MEMORANDUM DATE: June 2, 2021

RE: **1420 South Palmway**

TITLE: **HRPB Project Number 21-00100118:** Consideration of a Certificate of Appropriateness (COA) for partial window replacement for the property located at **1420 South Palmway**; PCN #38-43-44-27-01-077-0040. The subject property is a non-contributing resource to the South Palm Park Local Historic District and is located within the Single-Family Residential (SF-R) zoning district.

Existing Windows

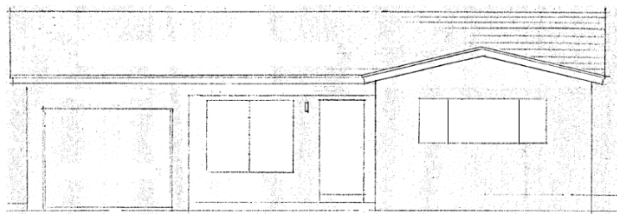
The existing two openings on the front façade feature a pair (left opening) and a triplet (right opening) of “colonial awning” windows. These windows are typical horizontal pane awning windows which utilized vertical muntins to create the appearance of divided-light windows. They were utilized on more traditionally inspired mid-century buildings through the 1970’s, when awning windows began to fall out of favor with residential builders. They marked an important transition in American design as the modernist approach of the 1950’s and 1960’s segued into to renewed interest in Colonial Revival residential architecture and classical detailing and proportions.

Proposed

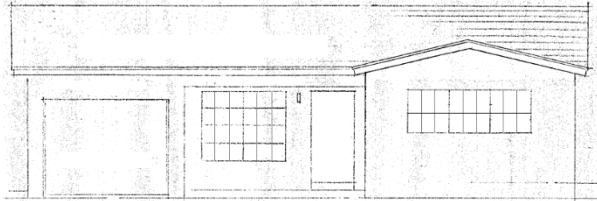
The current request is for an XO horizontal roller for the window on the left, and an XOX (quarter – half – quarter configuration) horizontal roller for the window on the right. The proposed configurations are full-view, and do not attempt to replicate the windows being removed, or a compatible alternative for the structure’s architectural style.

The staff recommended partial window replacement (Option A or B) could be approved administratively at permitting as they are Design Guidelines compliant. The partial window replacement, as proposed, could not be approved administratively as the window configuration and full-view appearance do not replicate the existing windows or an architecturally compatible window type. A full-view horizontal slider (OX or XO) does not replicate the appearance of a pair of awning windows. In addition, a horizontal slider (XOX quarter-half-quarter configuration) does not replicate a triplet of equal-sized awning windows.
